Annual Monitoring Report
FINAL
Little Pine Creek II
Monitoring Year 4 of 7

New River Basin
HUC 5050001
NCDMS Project No. 856
DWR Project No. 20090048 (v.2)
Contract No. LP082819
USACE Action ID: SAW-2009-00591
Alleghany County, North Carolina
Data Collected: April 2023 – October 2023
Date Submitted: February 2024

Subject: Re: Draft MY04 Monitoring Report
Little Pine Creek II Mitigation Project, Alleghany County
DMS Project # 856
DEQ Contract #LP082819

CCPV MY4
Little Pine Creek II
Allegheny County, NC

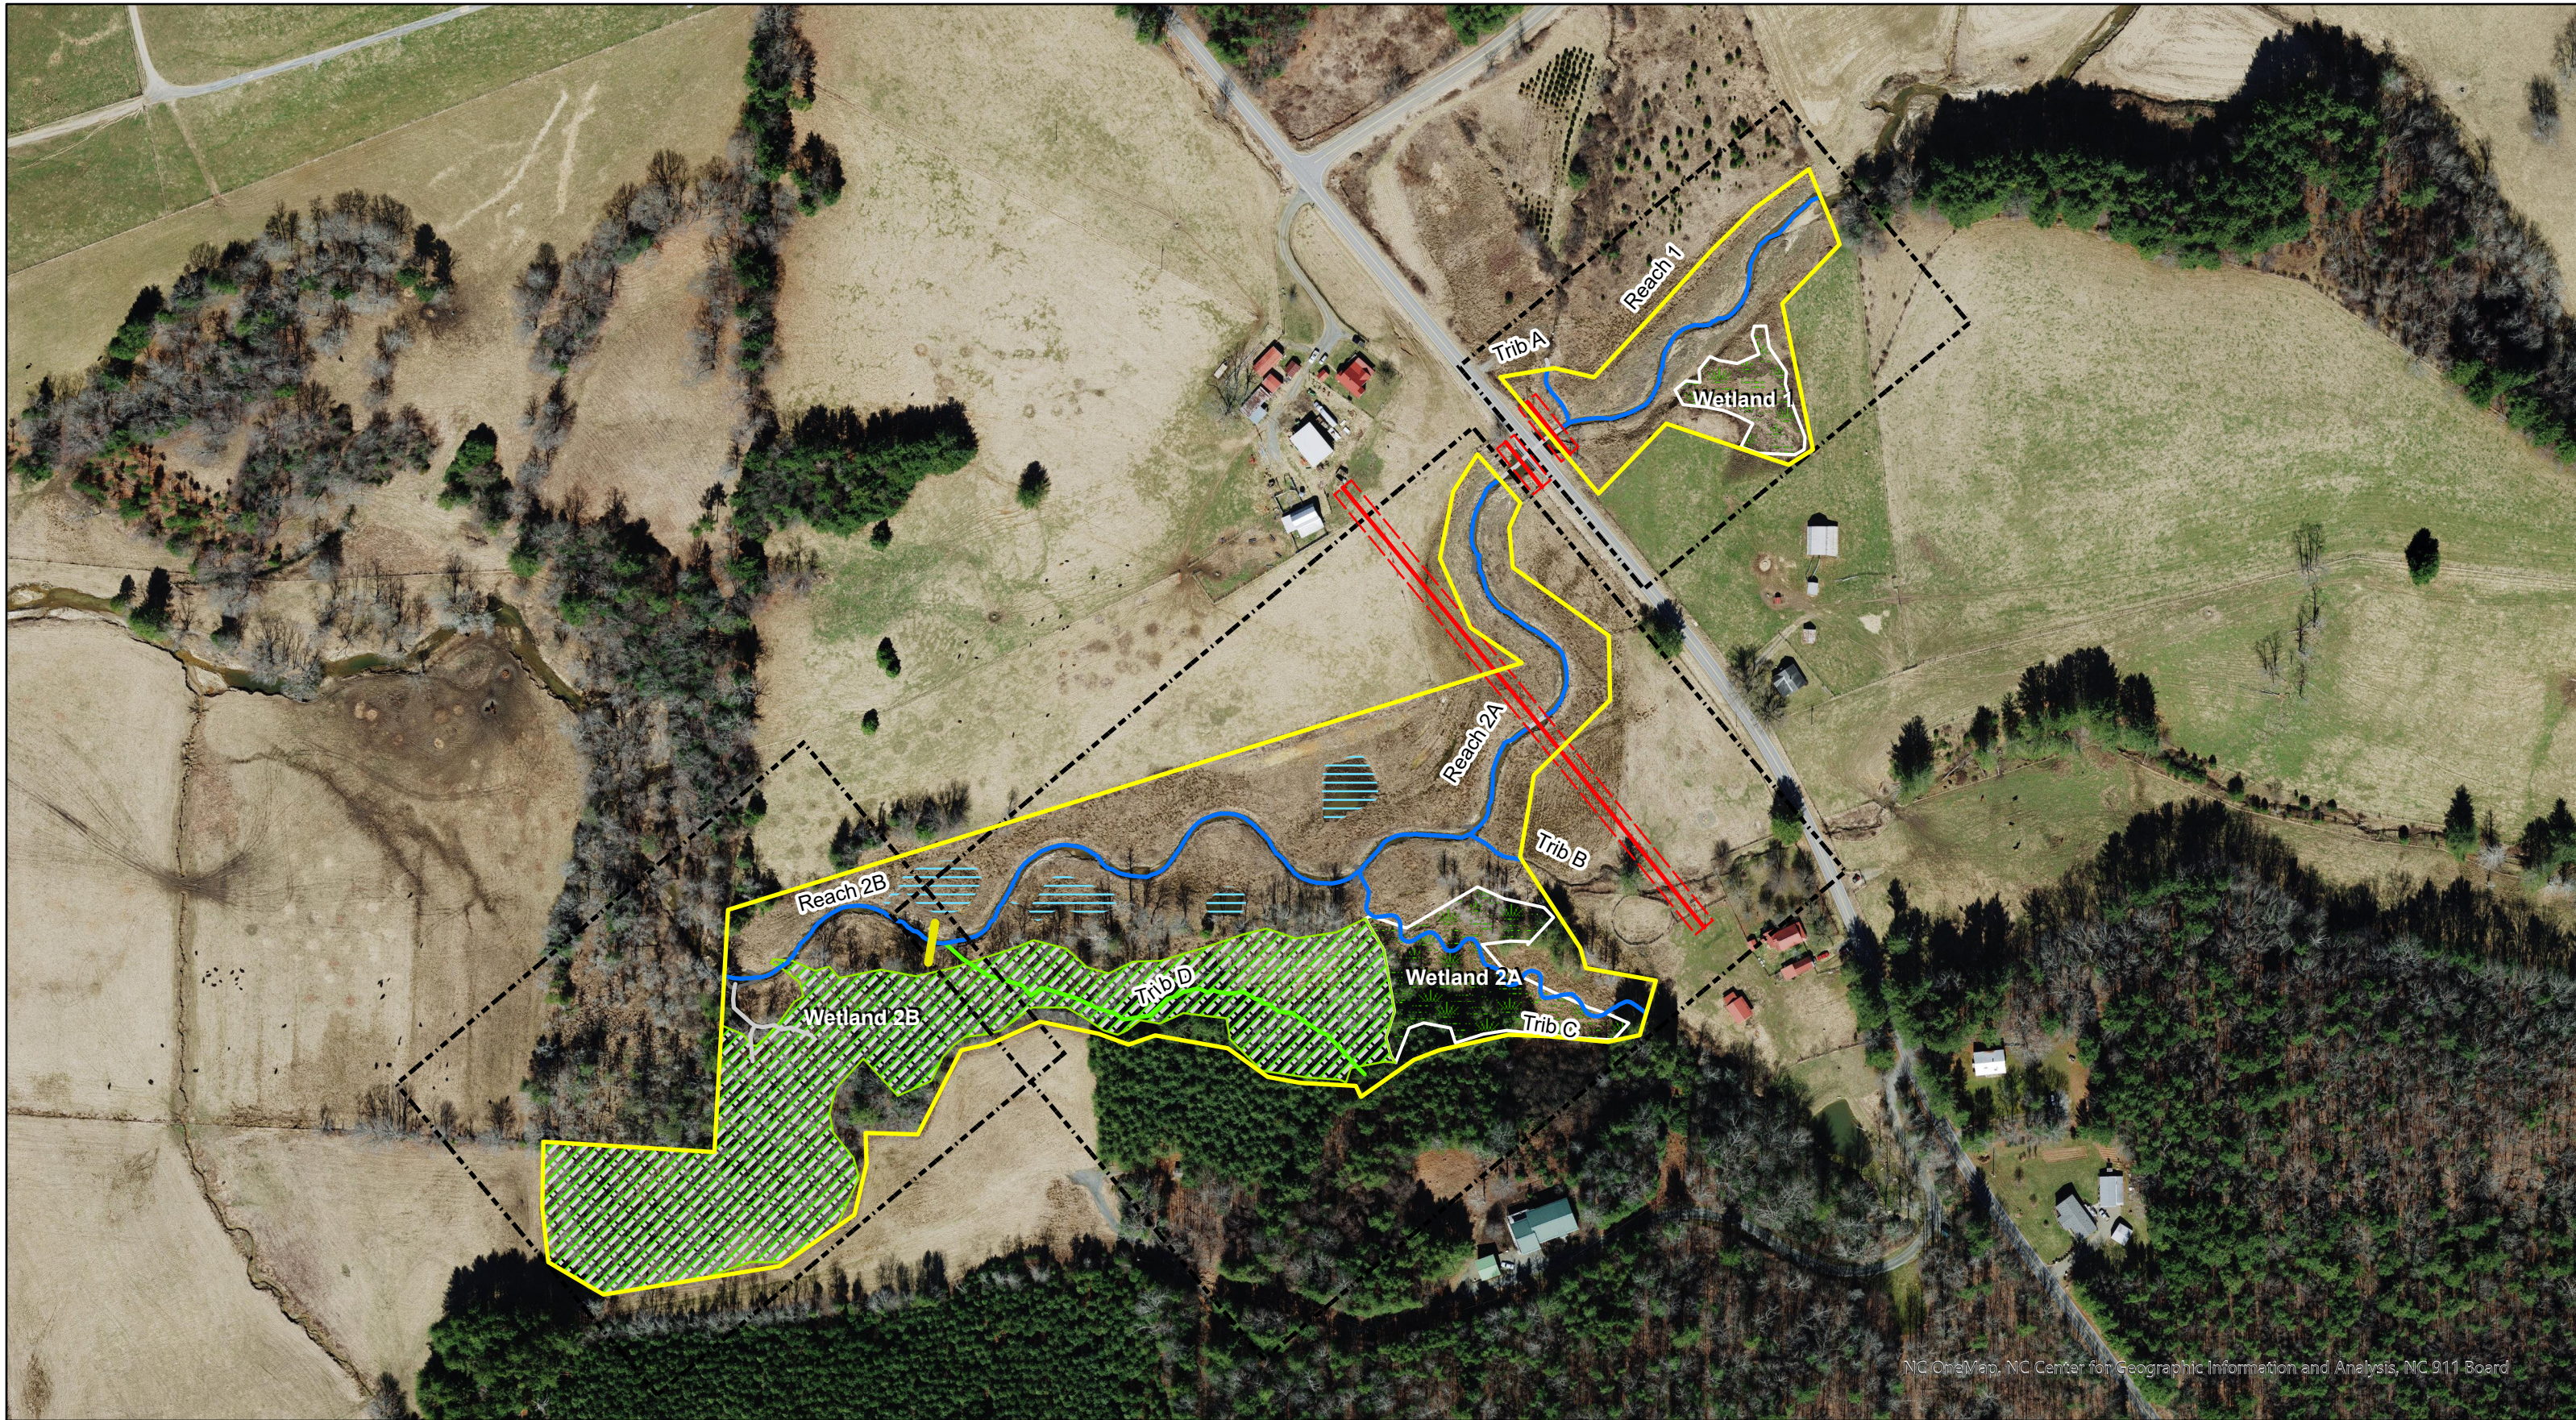
- Thank you for voluntarily upgrading the performance and goals table to include cumulative monitoring results. This is much appreciated.
- Please include the year of the aerial imagery; is this the most recent available? **Notation added to CCPV.**
